Independent Scientific Review Panel

Memorandum (2018-3)

Subject: Response Review of *Northern Pike Suppression and Monitoring* (project #2017-004-00)

Figure 1. Water sample locations in the Lake Roosevelt watershed used in the Northern Pike microchemistry study.

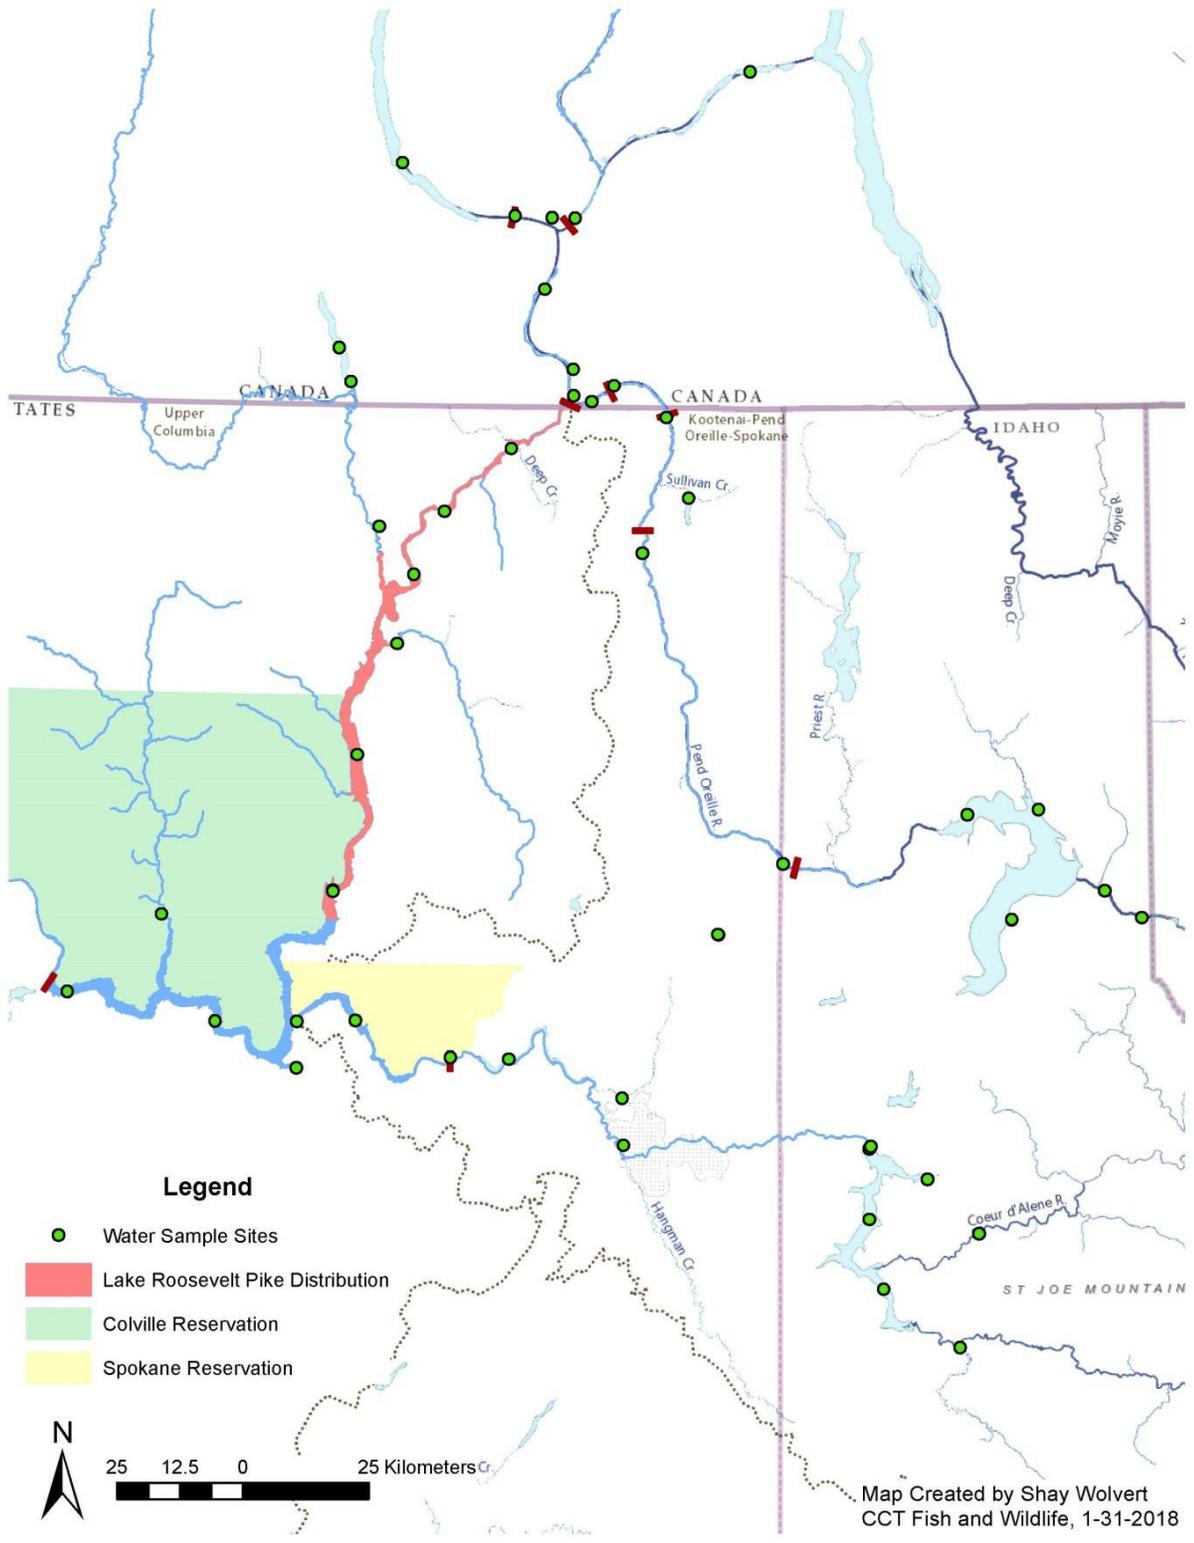
The response adequately covers the ISRP's question. The ISRP appreciates the map and the data presented in Figure 4 in the Plan (Figure 2 here).

Response: Seasonal water (spring, summer, fall) samples have been analyzed at 45 locations in the Upper Columbia watershed (Figure 1). See map below and maps within the NP Suppression Plan 2018-2022 document. This includes all major tributaries (Kettle River, Colville River, Spokane River, Pend Oreille River, and the Columbia River in Canada, and the Kootenay River).

Figure 2. Mean $^{87}\text{Sr}/^{86}\text{Sr}$ isotope values between the major waterbodies in the Upper Columbia River drainage.

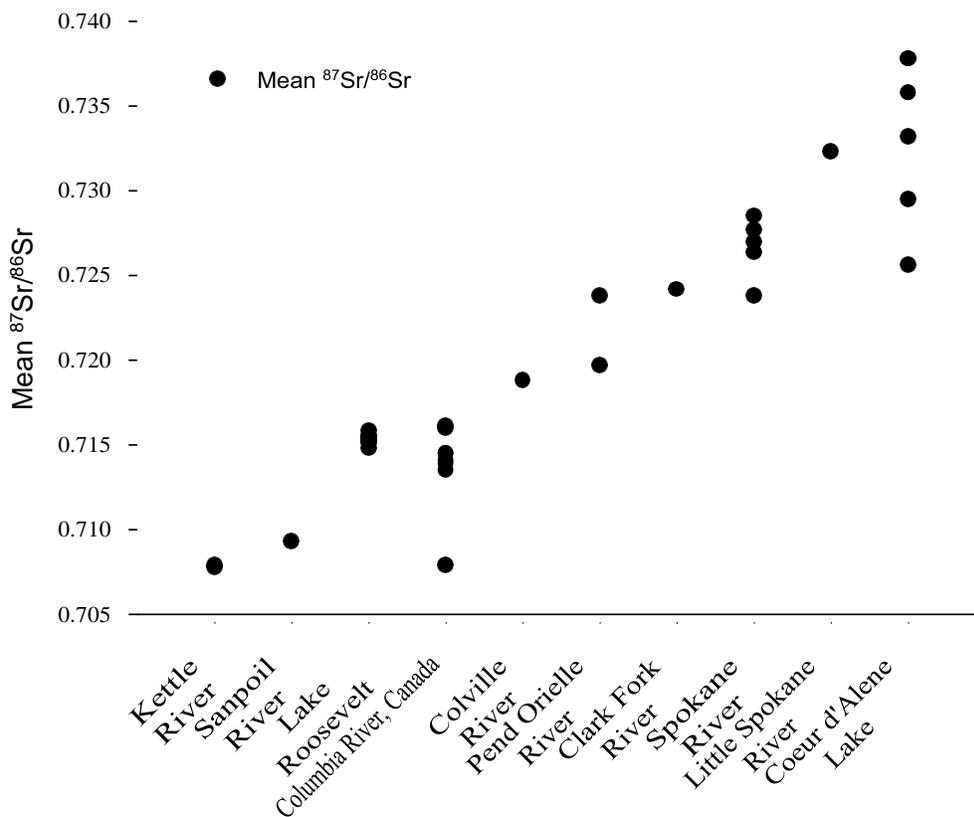
(a) Natal origin: The isotope concentrations presented in Figure 4 differ little between the Canadian Columbia River Basin and Lake Roosevelt, so this method (alone) appears to be inadequate to identify northern pike originating from the Canadian Columbia River Basin, i.e., one of three key areas of interest. The Plan should clearly state how it will identify northern pike originating from the Canadian Columbia. When examining isotope transitions along the otolith axis, the age at which the transition occurs should be estimated (see Fig. 5).

However, the mainstem Columbia River values only vary slightly from upstream to downstream (Figure 2). Consequently, microchemistry is useful for understanding if and when Northern Pike enter Lake Roosevelt from tributaries, but not useful for understanding movements within the Columbia River itself.
